SERVICE BULLETIN

ENGINE - Fan Rotor Assembly - Introduction of Spinner Cones, Stage 1 Blade Spacer, and Blade Retainer

(CF6-6) 72-396
Page 3 of 12

Figure 1
Fan Rotor Assembly

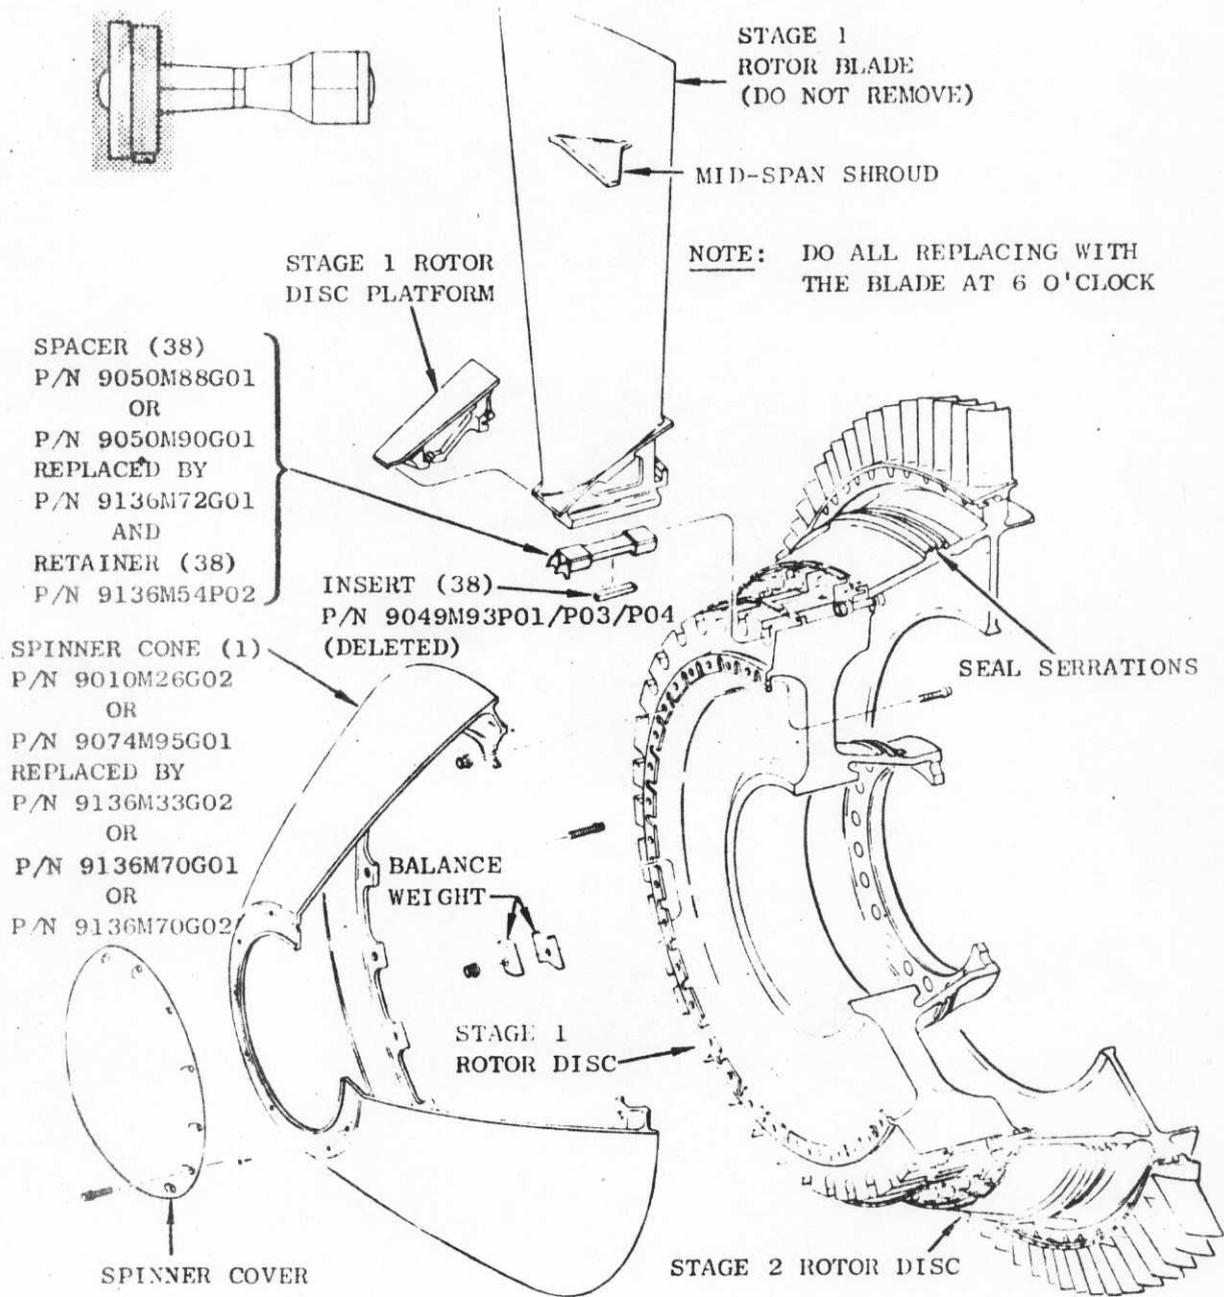
With the Spinner Cone and Stage 1 Fan Rotor Blades accessible, refer to Figure 1 and accomplish the following:

- (1) Remove the Spinner Cone (P/N 9010M26G02 or P/N 9074M95G01). Retain attaching hardware for reinstallation. Dispose of the Spinner Cone per paragraph 3.D. Parts Disposition.
- (2) Remove the Spacer (P/N 9050M88G01 or P/N 9050M90G01) and the polyurethane Insert (P/N 9049M93P01, P/N 9049M93P03, or P/N 9049M93P04. These parts will not be re-used.

Figure 2
Spacer and Retainer Installation

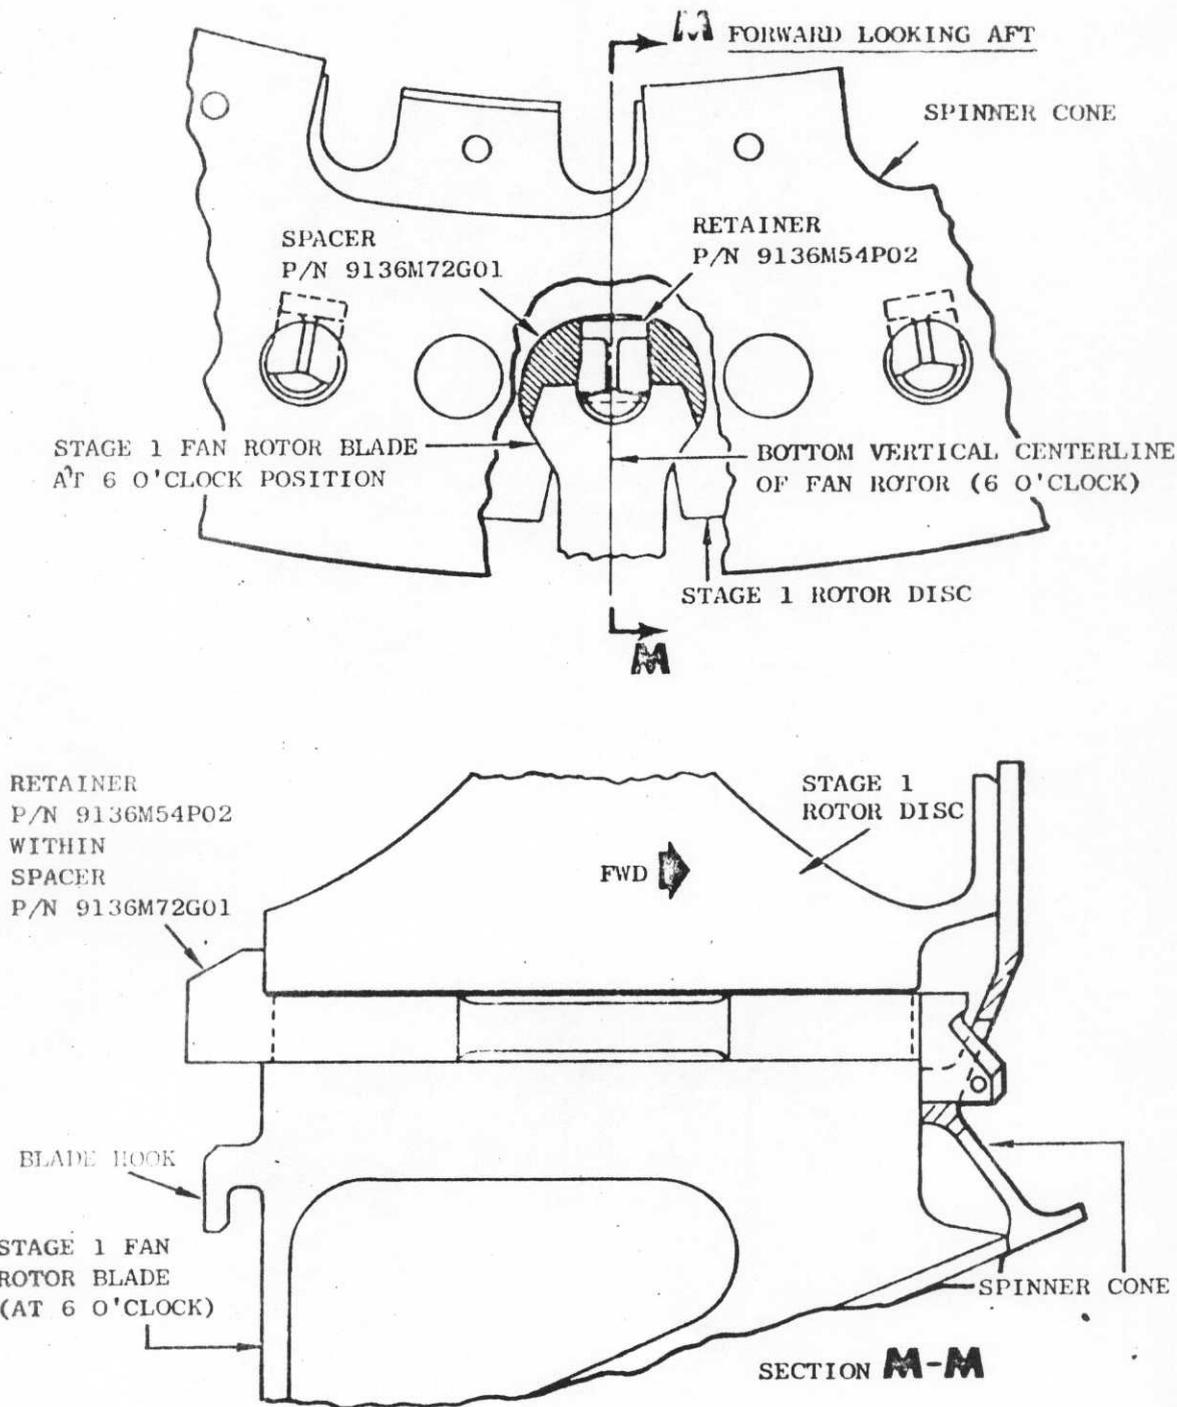
- (8) Carefully tap the Spacer and Retainer assembly until the aft face of the Forward Head of the Retainer bottoms against the forward face of the Fan Rotor Blade Dovetail.
- (9) Rotate the Retainer so that the hole in the forward end is radially outboard as shown in Figure 2. This is 90° from its position during insertion into the dovetail slot. The forward end or head will then cover the forward end of the Fan Rotor Blade dovetail while the aft end engages behind the Fan Rotor Disc to help prevent the blade from moving forward.

NOTE: The forward end of the Retainer should be pointing outboard within 8° of a radial line to prevent interference with the reworked Spinner Cone.

Figure 3
Protective Shield for Spacer
and Retainer Installation

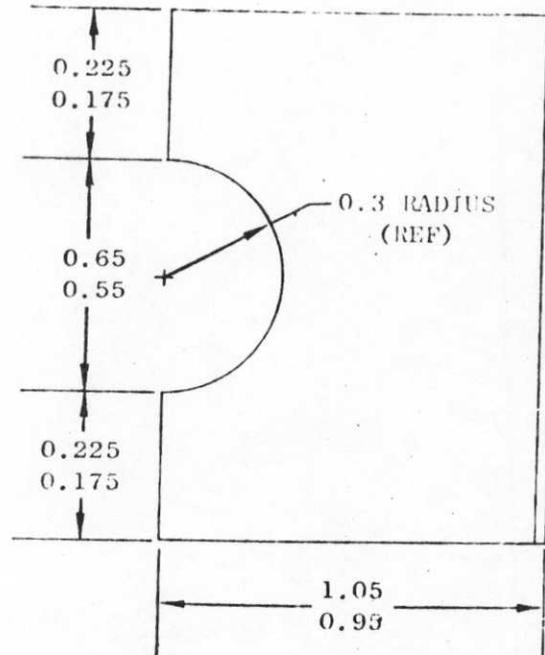
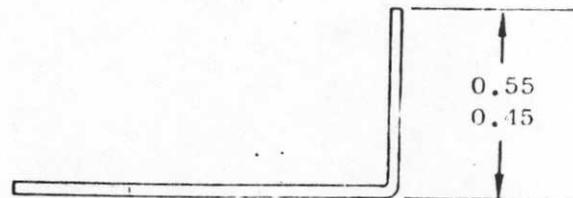
Locally-manufacture Protective Shield per Figure 3.

- (5) Using a plastic or raw-hide hammer, carefully drive the Spacer and Retainer assembly approximately half-way into the dovetail slot.
- (6) Assemble the locally-manufactured Protective Shield to the assembly so that the slot slips over the shank of the Retainer between the aft side of the Forward Head of the Retainer and the forward end of the Spacer. The purpose of this shield is to protect the forward face of the Stage 1 Disc and forward edge of the dovetail slot. Refer to Figure 3.

MATERIAL: STEEL SHEET
NOMINAL THICKNESS 0.03" (0.8 MM)
